Remarks

Proposed drawing corrections are enclosed and highlighted in red. The corrections replace or add several reference numerals; so that, the drawings correspond to the related text. The corrections also correct minor informalities discovered by the Applicants. No new matter has been added.

Version with markings to show changes made

Figure 4

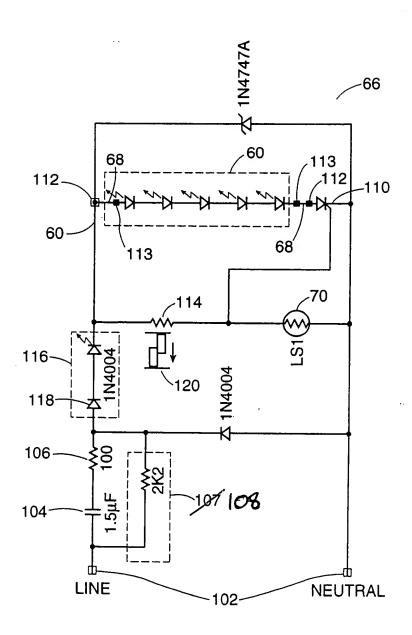
Power circuit 66 comprises the components outside circuit 60 in Fig. 4. In power circuit 66, capacitor 104 and resistor 106 cause the -- <u>line voltage 102</u> [voltage] -- in power circuit 66 to drop to a level which can be handled by light circuit 60. Alternatively, capacitor 104 and resistor 106 may be replaced by single resistor 108. Single resistor 108 must be of sufficient resistance to drop the voltage to the required operating levels of light circuit 60. It can be appreciated that a variety of known circuit arrangements are available which may be utilized to effectively drop the 120 volt AC signal to a signal which can be used by light circuit 60.

F16.
Figure 9a

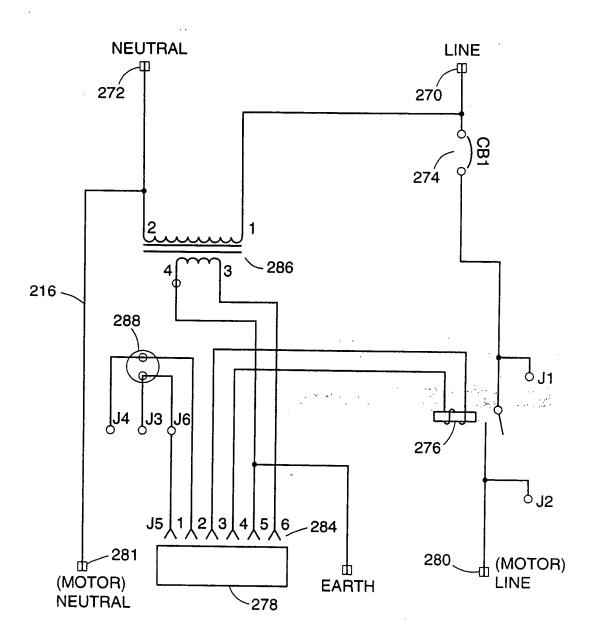
Transformer 286 provides a 24-volt signal -- [appears] -- between terminals 286(3) and 286(4) when a 120-volt AC signal is present between terminals 270 and 272 -- [(Fig. 9a)] --. Relay 276 is energized on the positive portion of an AC signal between terminals 286(3) and 286(4), via auxiliary circuit 278. Controller 216 interfaces to auxiliary circuit 278 through connector 290.

Figure 12

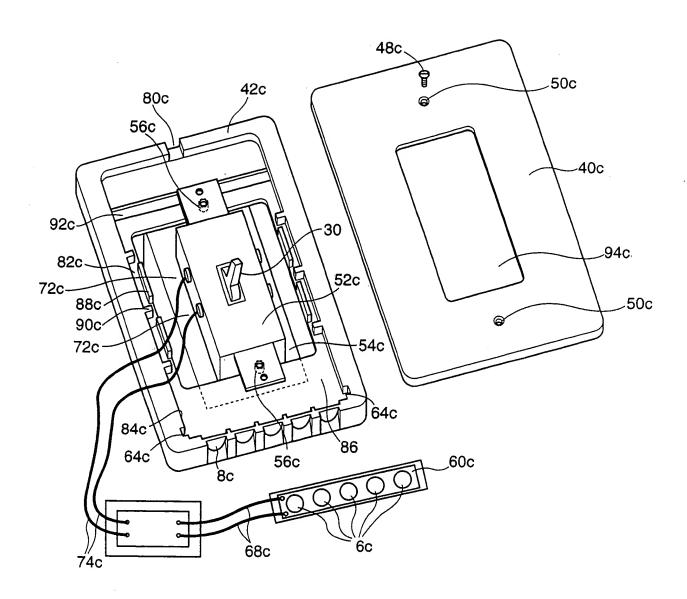
Referring to Fig. 12, the layout of components of frame assembly 2c is similar to the layout for components for frame assembly 2b (Figs. 3a and 3b). Light switch 52c is mounted to electrical box 54c via screws 48c inserted through -- apertures 50c and -- hollow spacers 56c on frame 42c. Hollow spacers 56c allow -- [connections 58c of] -- light switch 52c to be flush with the front surface of cover 40c.
